a. Pacific Star Estates: Master Development Plan and Tentative
Subdivision (File Nos.: 711-23-000227-MD and 711-23-000228-SP)

STAFF RECOMMENDATION FOR PACIFIC STAR ESTATES MASTER DEVELOPMENT PLAN AND TENTATIVE SUBDIVISION

REQUEST: Approval of a master development plan and a nine-phase tentative subdivision on 34.2 acres.

SHEET TITLE: TENTATIVE PLAT

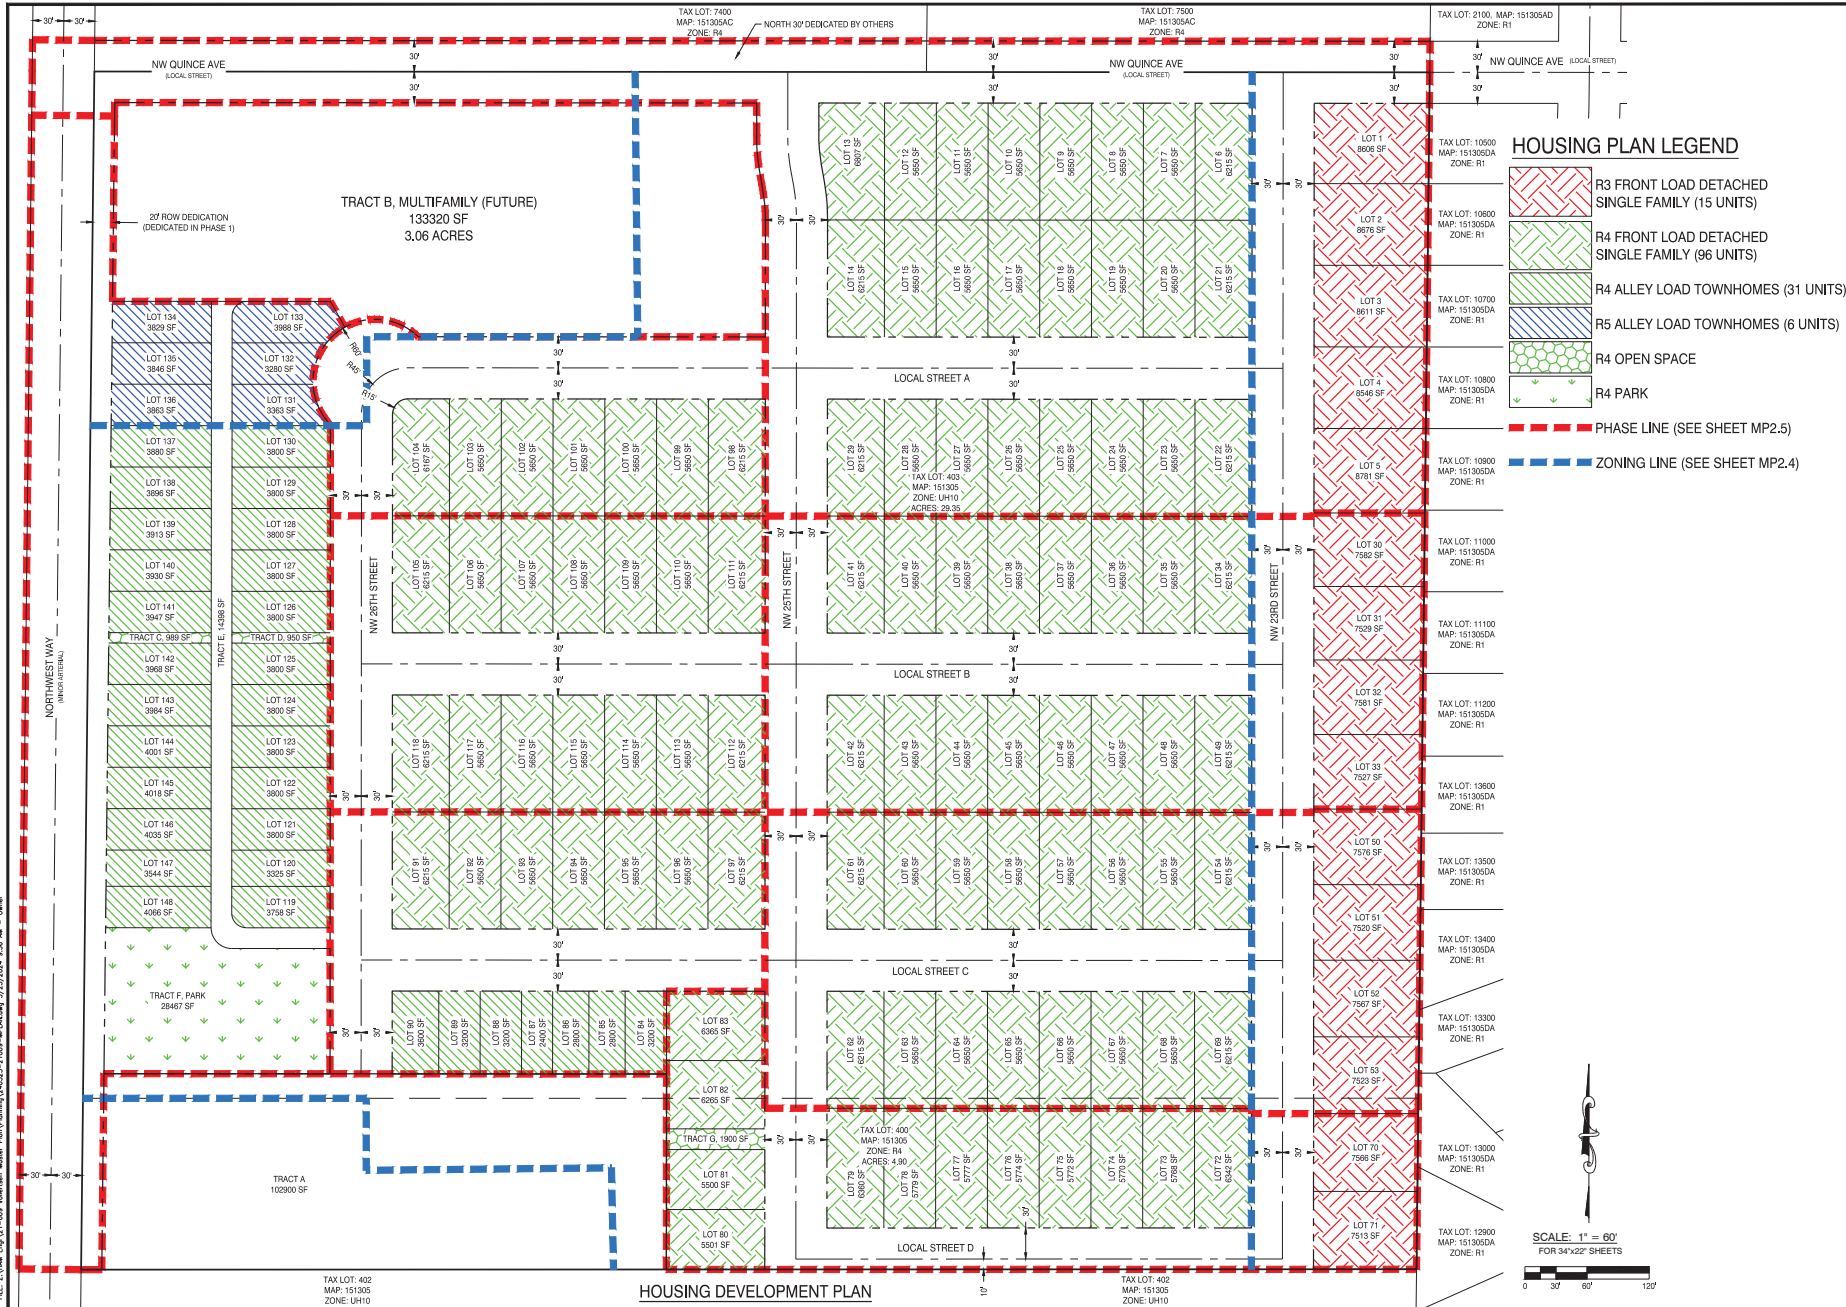
1. **Transportation:** All public streets shall be designed, constructed and dedicated to current City of Redmond Standards & Specifications and Transportation System Plan (TSP) standards and extended to the limits of each project phase unless otherwise specified or approved. Five (5) ft. minimum width public utility easement (PUE) shall be dedicated along all street right-of-way per COR Standard Drawing 2-1. Street signage, lane striping, street lights and postal box installation shall be required. Barricades shall be required on all dead-end streets at phase/property boundaries and signed for future extension. All street names shall be approved by Redmond Fire and Rescue and/or Deschutes County. The proposed master plan and public street system complies with City street and TSP standards subject to the following: [COR Code 8.0270(2)(D), 3(B)(1)(a), 3(C)(11) & 3(C)(14)(a))] [COR Code 8.2240(1 & 4) 8.2320(2)(A), 8.2710(1, 2, 3 & 10) & 8.3035(2)] [CORPWSS Development Provisions 03]

A) **Northwest Way (NW 27th St)** - minor arterial street. A paved road and sixty (60) ft. public right-of-way exist, no curb or sidewalk, along project/property frontage. Prior to and/or with Phase 1 plat approval, twenty (20) ft. public right-of-way dedication shall be required along property/project frontage for a total width of fifty (50) ft. east of centerline per City minor arterial standards. Street and right-of-way centerline shall match existing. Prior to Phase 4 plat approval, street frontage improvements conforming to City minor arterial street standards per COR Standard Drawing 2-1 shall be required and constructed along project/property frontage as follows, unless otherwise approved by the City Engineer:

- C) **NW 23rd St. & 25th St.** - local streets. Street improvements conforming to City local street standards shall be required per COR Standard Drawing 2-1 with new 36 ft. wide pavement, curb, sidewalk, storm drainage and sixty (60) ft. right-of-way dedication. SW 25th St. shall match the neighboring Dry Canyon Village approved plan.

- D) **NW 26th St. & Local Street A, B & C** - local streets. Street improvements conforming to City local/cul-de-sac/eyebrow street standards shall be required per COR Standard Drawing 2-1, 2-4 and 2-5 with new 36 ft. wide pavement, curb, sidewalk, storm drainage, sixty (60) ft. right-of-way dedication and fifty-four (54) ft. cul-de-sac radius right-of-way dedication unless otherwise approved by the City Engineer.

- E) **Local Street D** - local street. Street frontage improvements conforming to City partial local street standards shall be required per COR Standard Drawing 2-1 and 2-3 with new 25 ft. wide pavement, curb and sidewalk on the north side, storm drainage and forty (40) ft. minimum right-of-way dedication as proposed along project/property frontage unless otherwise approved by the City Engineer.

- F) **Public Pedestrian/Bike Multi-Use Path** - the separated public pedestrian/bike multi-use path identified as B13 along Northwest Way property frontage per City 2020 Transportation System Plan (TSP) shall be constructed and dedicated per COR Standard Drawing 2-6 for multi-use paths unless otherwise approved by the City Engineer and City Parks Division.
